## ZLIN AIRCRAFT a.s.

## MANDATORY SERVICE BULLETIN Z 143L/1a - Rev. 1

Supersedes Mandatory Service Bulletin Z 143L/la dated August 8, 1995

Fig. 1. : THE AUXILIARY TANK FILLER FLAP

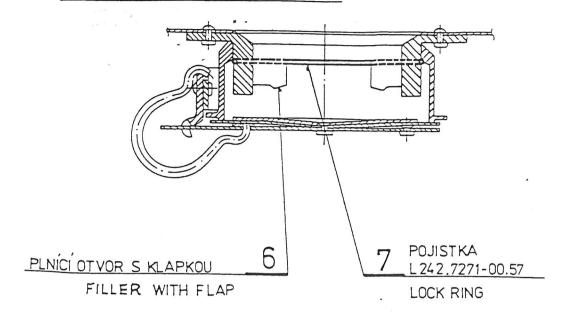
When handling the auxiliary tank cap, the wire lockring on the auxiliary tank filler flap can loosen.

8.1 Check by touch or visually with the mirror whether the lock ring (Item 7 - See Fig. 1) is properly positioned in the groove of the auxiliary tank filler flange (Item 6). If the lock ring is not properly sitting in the groove, reset it.

- 3.1 Check the correct position of the lock ring in the groove of the auxiliary tank filler flange.
- 3.2 Replace the auxiliary tank cap springs.
- 4. TIME OF COMPLIANCE: Immediately after receipt of this Bulletin.
- 5. CORRECTION PERFORMED BY:

Fig. 2.: AUXILIARY TANK CAP

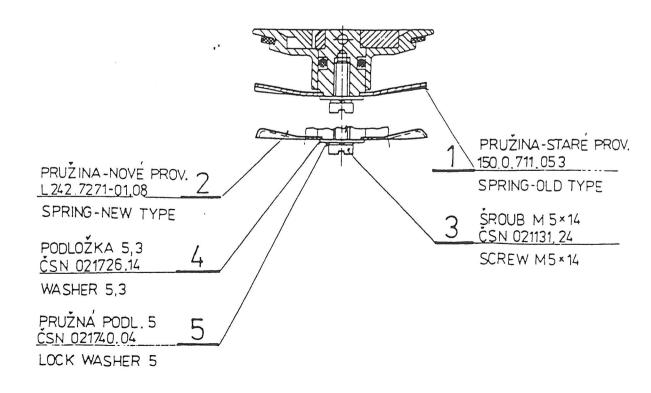
8.2 Remove the closure spring (Item 1, P/N 150.0.711.053) and replace it by the new one (Item 2, P/N L 242.7271-01.08). The screw M 5x14, Item 3, is secured in the threads by the bonding agent - LOCTITE (ALDURIT). It is recommended to preheat the screw (Item 3) by applying the electric soldering iron to the screw head because of easier removal. At reassembly of Items 3, 4, 5, secure the screw (Item 3) by application of the above-mentioned bonding agent to the screw threads.

2 pcs of the spring L 242.7271-01.00 for one (1) aircraft; Delivered together with this Bulletin by the manufacturer.
